E5063A-09A

Information Only Service Note

E5063A ENA Series Network Analyzer

The Situation - New Touch Panel & Touch Panel Controller Available

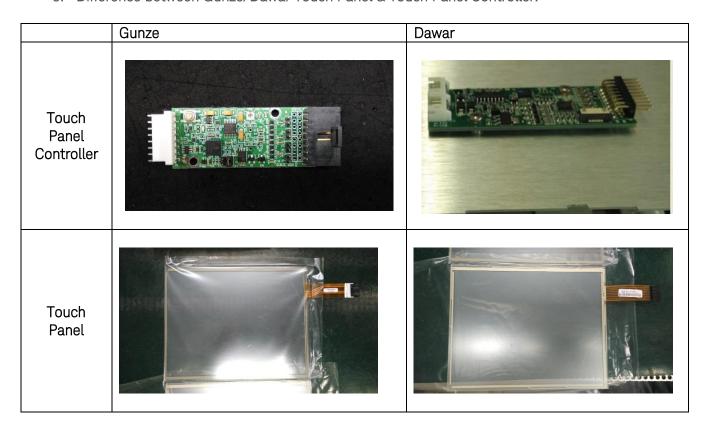
- 4. Backward compatibility of E5061-60113 to the existing E5061-60112:
 - No, the E5061-60113 is not backward compatible to E5061-60112.
- 5. Difference between Gunze/Dawar Touch Panel & Touch Panel Controller:

Touch Panel at the Top: Gunze, Touch Panel at the bottom: Dawar

Figure 1 Connection of Dawar Touch Panel & Controller Board

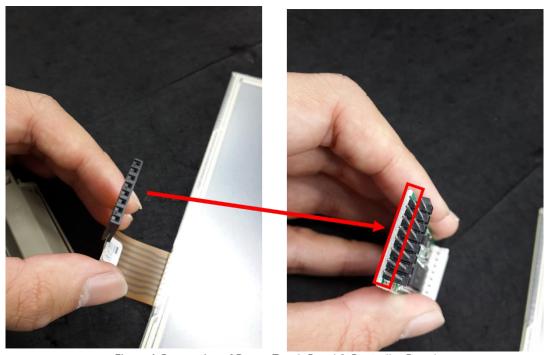
1. Connect Dawar Touch Panel to Dawar Touch Panel Board/Controller as shown in Figure 1Figure 5 below. The cable must be connected to the lower row of the pin. The hole of the cable from touch panel should be facing inwards, which mean that after connecting to the controller board, the hole of the cable should not be viewable. Please refer to Figure 2, Figure 3 and Figure 4 for the picture of the connection.

Figure 5 Connection of Gunze Touch Panel & Controller Board

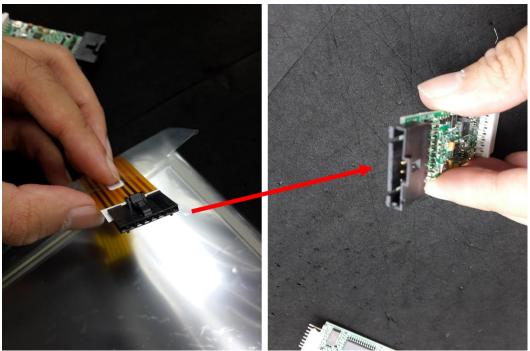
1. Connect Gunze Touch Panel to Gunze Touch Panel Board/Controller as shown in Figure 5 below. The Figure 6 shows complete connection of Gunze Touch Panel and Touch Panel Controller Board.
